**BID FORM**

SW 40<sup>th</sup> Blvd Extension (SW 47<sup>th</sup> Ave – Archer Rd) & SW 47<sup>th</sup> Ave Multiuse Trail (SW 40<sup>th</sup> Blvd – SW 34<sup>th</sup> St)

**110-1 Description.**

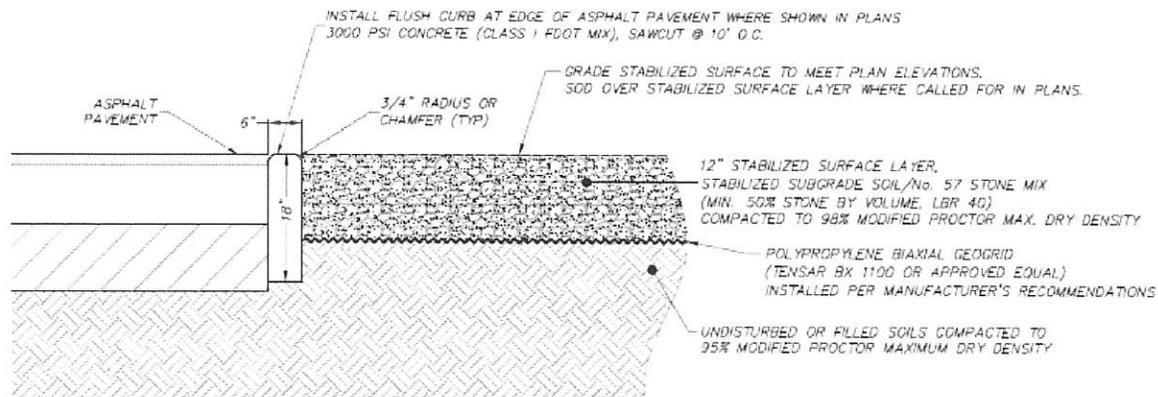
7. Question: What work is covered by the pay item, "Miscellaneous Demolition"? I did not see this covered in the specifications.

Answer: Please refer to FDOT Item # 0110 1 2. This item is described as follows:

Clear and grub within the areas shown in the Plans. Remove and dispose of all trees, stumps, roots and other such protruding objects, buildings, structures, appurtenances, existing flexible asphalt pavement, and other facilities necessary to prepare the area for the proposed construction. Remove and dispose of all product and debris not required to be salvaged or not required to complete the construction.

*Perform miscellaneous work necessary for the complete preparation of the overall project site as specified in 110-10.*

*INDEX OF ROADWAY PLANS*

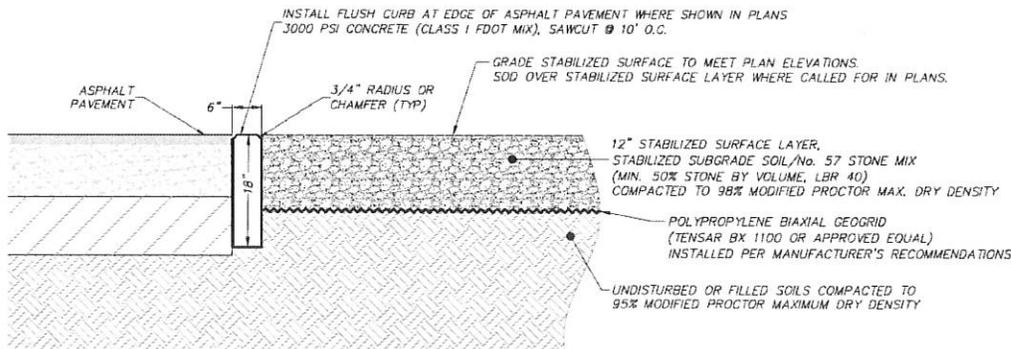
3. Question: Sht.#10 missing from plans

Answer: Correct. Please refer to the cover sheet of the SW 40<sup>th</sup> Boulevard Extension Project. This sheet was not used.

SILT FENCE DETAIL

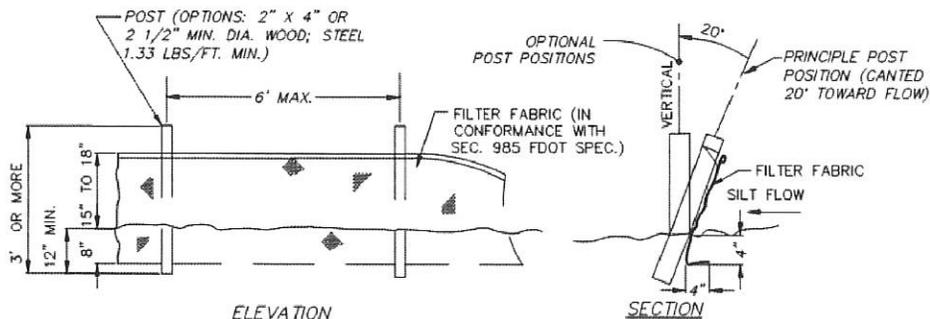
6. Question: Plans indicate Silt Fence, but Pay item is for Staked Turbidity Barrier

Answer: Please use Pay item 0104 10 "Sediment Barrier" instead of Pay item 0104 12. Refer to the silt fence detail on Sheet 11 for typical installation.
